UNEP/OzL.Pro/ExCom/73/54/Add.1  
31 de octubre de 2014

**INFORME SOBRE EL INDICADOR DE IMPACTO  
CLIMÁTICO DEL FONDO MULTILATERAL (IICFM) (DECISIÓN 69/23)**

## Review of the Multilateral Fund Climate Impact Indicator (MCII)

## Total lifetime climate impact of one year of production [tCO2e]

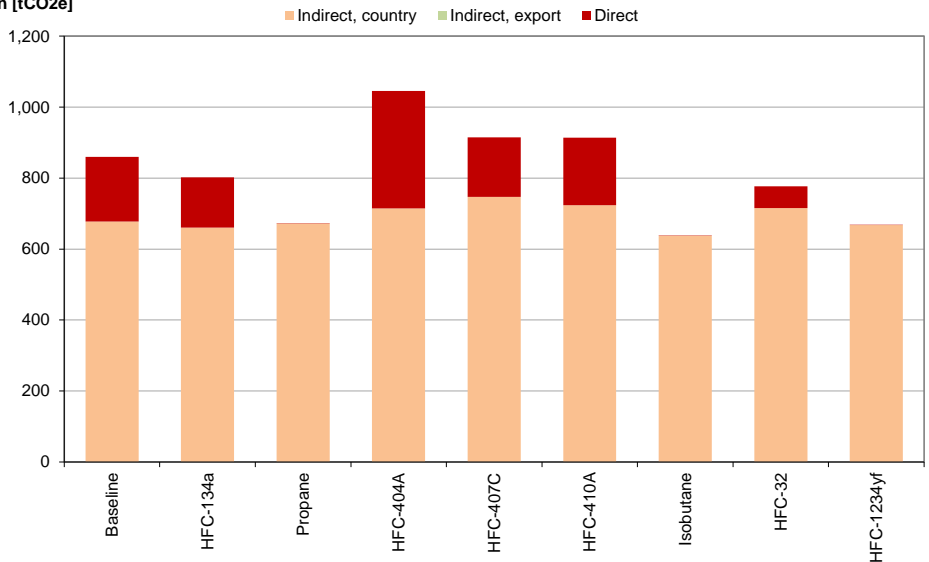
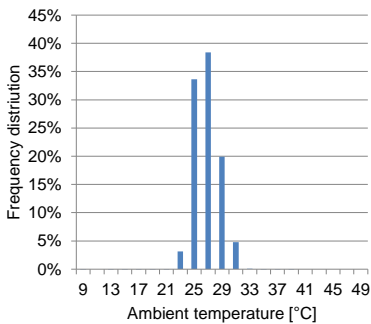
To review results generated by MCII, I performed an analysis for an air-conditioning unit in Seychelles (attached). My observation is that the obtained results on indirect impact for different fluids are not correct to a degree that will provide incorrect relative rankings of alternative fluids.

The MCII analysis shows that the transition from R22 to isobutane and R-1234yf will result in a reduced indirect effect, i.e., improved equipment efficiency. On the other hand, transition from R22 to R410A and R32 will result in an efficiency decrease, while a change from R22 to propane will be efficiency neutral. These results correlate with critical temperatures of the analyzed fluids (fluids with a lower  $T_{crit}$  (R410A and R32) have a lower efficiency than fluids with a high  $T_{crit}$  (R134a, isobutene and R1234yf); because of the modeling methodology they may correctly represent relative performance of these fluids in chiller systems employing shell-and-tube heat exchangers (pool-boiling and space-condensation refrigerant heat transfer).

However, the obtained results are in disagreement with the current recognition of relative merits of refrigerants applied in systems using optimized serpentine heat exchangers (forced convection evaporation and condensation heat transfer), such as residential and small commercial units. To start with propane, the literature is full of claims of propane having a 5 % - 10 % better efficiency than R22<sup>2</sup>. Regarding R410A, the industry learned to optimize R410A heat exchangers and to match  $COP_{R22}$  with R410A systems. Our 2006 study<sup>3</sup> confirmed the COP equivalency between R22 and R410A. It also indicated that R134a and isobutene will underperform R22, propane and R410A in an optimized system (when transport properties and system effects are accounted for), while the MCII model predicts isobutene and R134a to be the most efficient fluids.

In conclusions, I believe that the MCII overrates low-pressure fluids (such as R134a, isobutane, and R1234yf) and underrates high-pressure fluids (R410A, R404A, and R32) by not considering the  $dT_{sat}/dP$  relationship.
